SIB 41 02 20

2020-08-24

TRUNK LID RUBS ON BUMPER COVER

E-Series	Model Description
F44	2 Series Gran Coupe

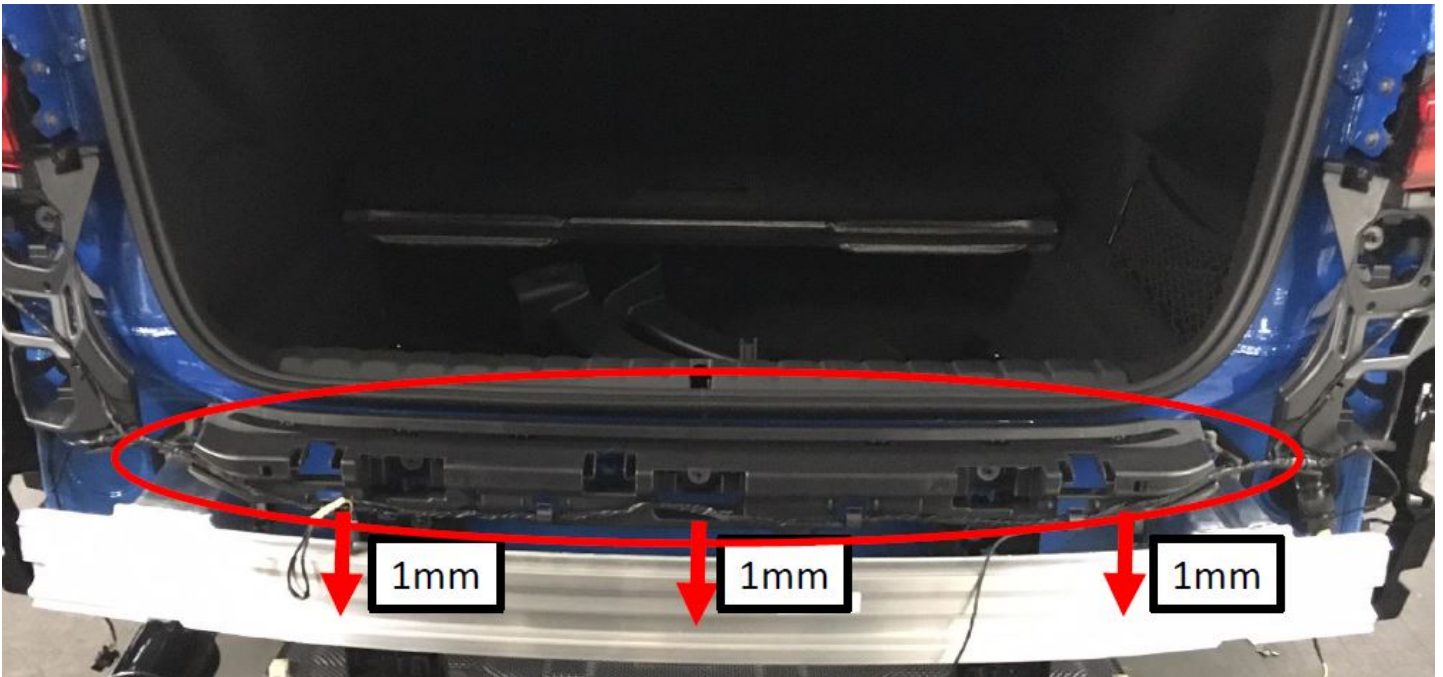
The trunk lid may slightly rub on the top of the rear bumper cover, causing scuff or scratch marks.

The rear bumper cover is adjusted too close to the trunk lid.

Adjust the rear bumper cover away from the trunk lid.

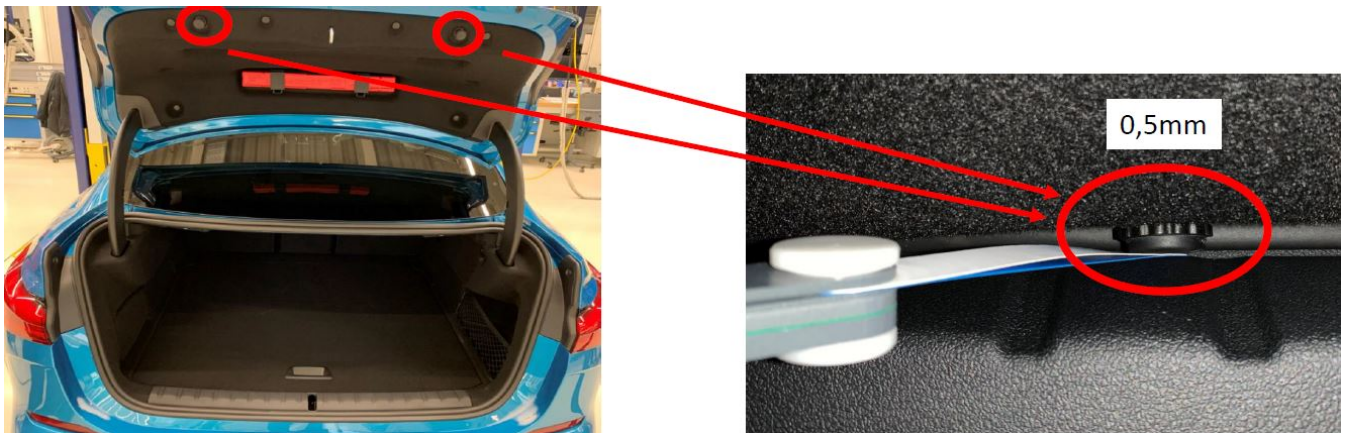
5. Measure the gap between the trunk lid and bumper cover on both bottom corners in the area shown below:

Is the gap at least 3.5 mm?

Yes: No further correction necessary

No: Continue to step 6.
